Sundry Notices and Reports on Wells

5. Lease Number
SF-078385A
6. If Indian, All. or
Tribe Name
7. Unit Agreement Name
8. Well Name & Number
Howell L #4
9. API Well No.
30-045-09009
10. Field and Pool
Blanco Mesaverde
11. County and State
San Juan Co, NM

MESAVERDE PLUG & ABANDONMENT PROCEDURE

Re: Permanent Abandonment

Proposed P & A

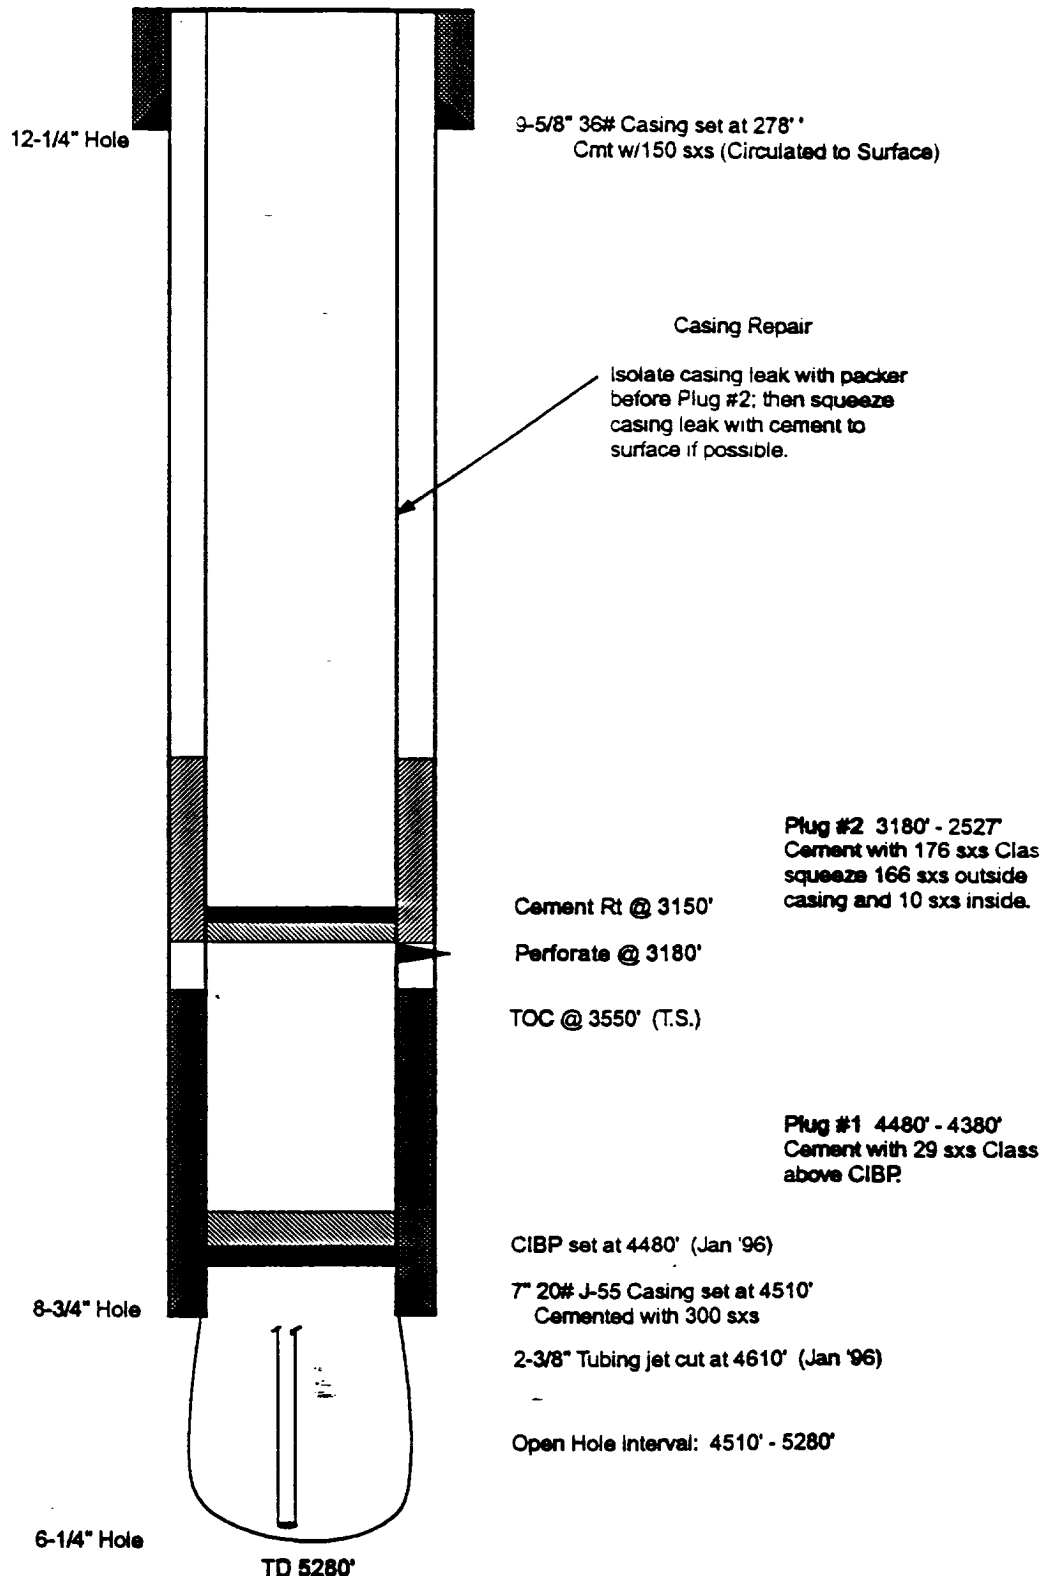
1. Plugging operations authorized are subject to the attached "General Requirements for Permanent Abandonment of Wells on Federal and Indian Lease."
2. Mike Flanikan with the Farmington Office is to be notified at least 24 hours before the plugging operations commence (505) 599-8907
3. The following modifications to your plugging program are to be made:
 - a) Place a cement plug from 3735' - 3635' to cover the Chacra, top @ 3685'.
 - b) Place the Pictured Cliffs/Fruitland plug (from 3180' - 2527') inside and outside the 7" casing.
 - c) Place the Ojo Alamo plug (from 2032' - 1732') inside and outside the 7" casing.
 - d) Place the Nacimiento plug (from 775' - 675') inside and outside the 7" casing.
 - e) Place the surface plug (from 328' - surface) inside and outside the 7" casing.
